# PROJECT REVIEW REPORT

<b>Project ID</b>	2410
<b>Project Name</b>	<i>Restoration of Degraded Forest Reserve Areas in Ghana, West Africa</i>
<b>Program(s)</b>	VCS
<b>Verification Period</b>	24 March 2016 to 01 November 2020
<b>Project Proponent</b>	<i>Miro Forestry Developments Ltd.</i>
<b>Methodology</b>	<i>AR-ACM0003 A/R Afforestation and reforestation of land except wetlands, v2.0</i>
<b>Sectoral Scope(s)</b>	<i>14. AFOLU (Agriculture, Forestry and Other Land-Use)</i>
<b>Validation/Verification Body (VVB)</b>	AENOR

**Figure 1.** Fulani camps and route map

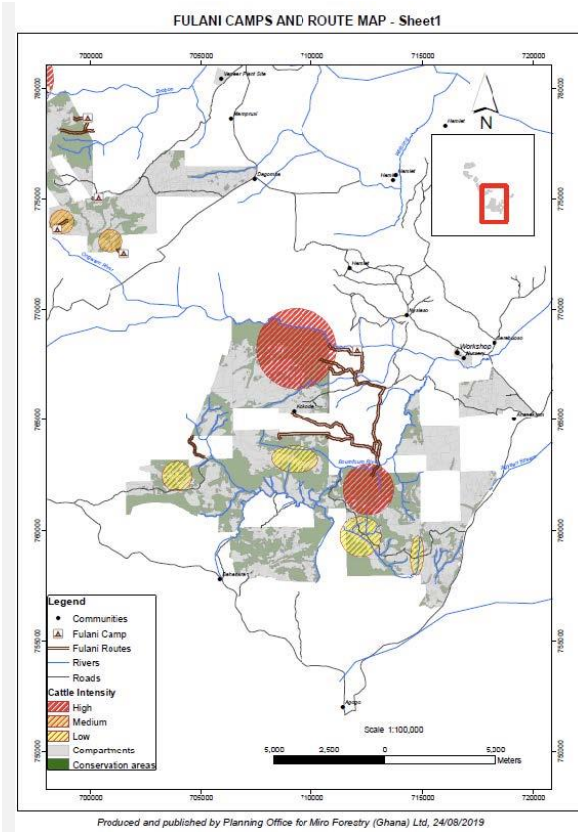
The project proponent is requested to update the relevant Sections of the joint project description and monitoring report to demonstrate that there was no displacement of grazing activities, or that the leakage due to grazing was accounted for as zero under one of the conditions listed in the methodology and to show evidence that the displacement of agricultural activities does not lead to an increase in GHG emissions relative to the GHG emissions attributable to the activity as it exists within the project boundary.

Concerning the presence of cattle in the forest reserves, it corresponds to the nomad herdsmen group of Fulani, moving south from Burkina Faso. Prior to any land development, Miro conducts a land use survey (example included as supporting document), grazing is never identified as permanent land use. However, Miro survey their movement to ensure that common routes (generally related to access to water) are kept clear for cattle movement (See next Figure):

In the same line, the company works with the Fulani to ensure they can still move through the area with no negative impact to Miro seedlings. Fulani are encouraged to travel through the more mature compartments (See next figure). This means, the project activities are a particular cause of displacement per-se, as they are nomadic and cattle movement is part of their tradition. Fulani herds use some routes through of the project area (see figures below), that means, their activity is not being relocated.

Having said that, as there is no displacement of grazing activities, since these activities are not permanent but seasonal, and can that they can still take place within the project area (Miro records their presence in the project area and it has not been any decrease – See monitoring report excel file attached), it can be concluded there will be no leakage.

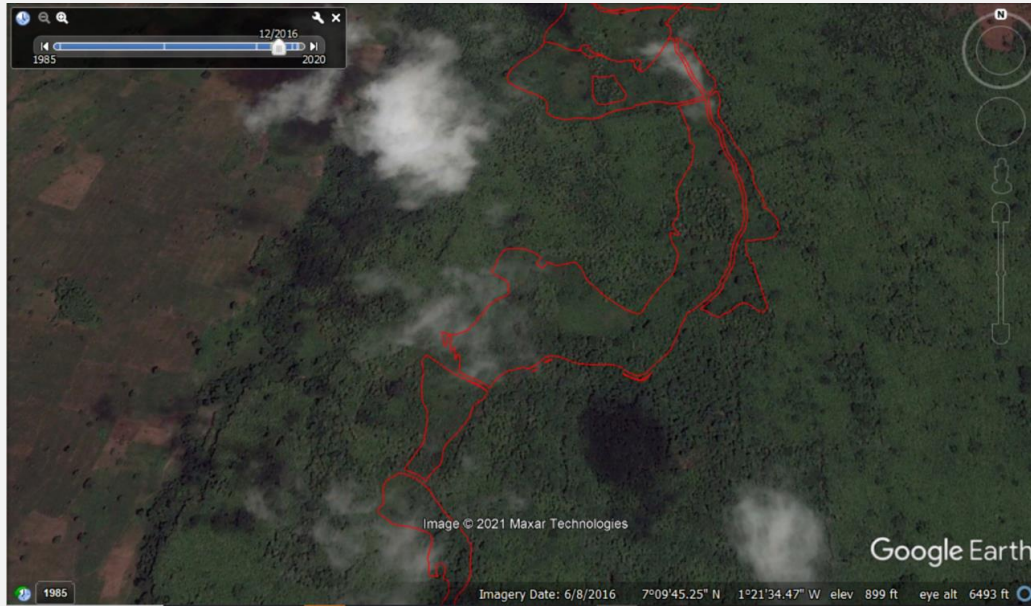
Based on satellite image reviewed (refer to the print screen below) for year 2016, there are other land cover types within the project area, which includes forests.

Section 4.1 of the joint project description and monitoring report does not stratify the baseline emissions based on biomass type in the project area.

The project proponent is requested to update Section 4.1 of the joint project description and monitoring report to stratify the baseline emissions based on land cover and biomass types within the project area.

It was indeed confirmed that there were forest present in the eligible area. Thus, a reassessment of the eligibility analysis was performed. Section 1.3 was updated and a total of 303,35 ha were removed from the eligible areas as they were identified as forest. As a result, the eligible area changed to 3,871 ha. In the same line, ex-ante and ex-post calculations were updated, considering the new eligible area. Updated excel sheets can be found in the supporting documents and also all sections related to the

Section 4.1 of the document was updated as well: From the same eligibility analysis, it is concluded that the only landcover present in the project area prior to the start of the project is Grassland
